We appreciate the very helpful feedback from the four referees. The referee's comments are listed in *italics*, followed by our response in **blue**. New/modified text in the manuscript is in **bold**.

## **Response to Referee #1:**

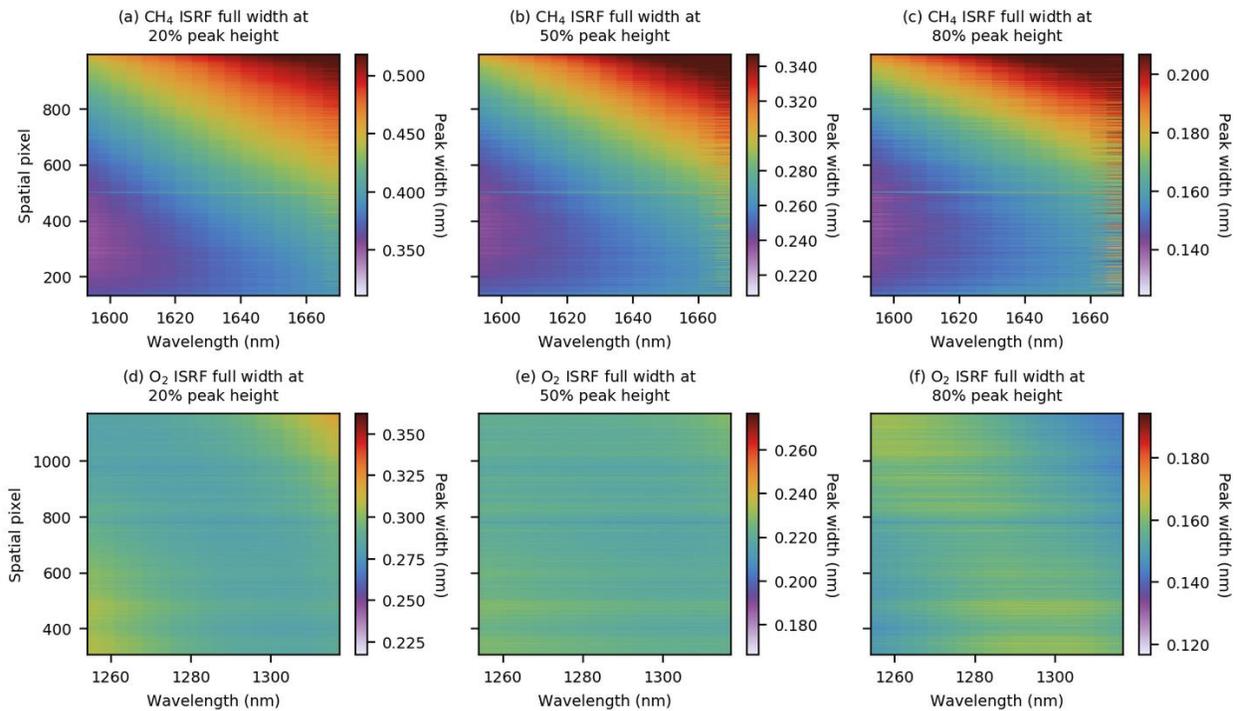
6. Figure 14: For the total ‘smoothed’ ISRF there are discrete transitions. It appears there is no truly smooth ISRF. Why was this done? Please explain.

*1. Spectral pixels vs. central wavelength: From line 11 the term central wavelength is taken to be that of the test laser source, where spectral pixel is a coordinate on the 2-D detector (spatial pixel being the other coordinate). However, Fig. 14 seems to use both central wavelength and spectral pixel inter-changeably. The abscissa of the plots is labeled Central wavelength, but the caption mentions spectral pixels..*

The transitions correspond to the discrete wavelengths where ISRF measurements were collected. Figure 14 has been updated using Gouraud shading in order to show the smooth ISRF variation across the FPA. The updated Figure 14 and caption is included here:

“Spectral pixel” does refer to a coordinate on the detector. In the original figure, “central wavelength” was used to label the spectral dimension because it is more meaningful than the spectral pixel index. Fig. 14 has been updated with Gouraud shading, effectively bridging the gaps between the central wavelengths. As such, the abscissa label has been updated to simply “wavelength”. The following sentence has been added to the caption of Fig. 14 for clarification.

**“Gouraud shading is applied to render smooth ISRF variation across the FPA. Wavelength labels have been projected to the abscissa in order to provide more context compared to the spectral pixel index.”**
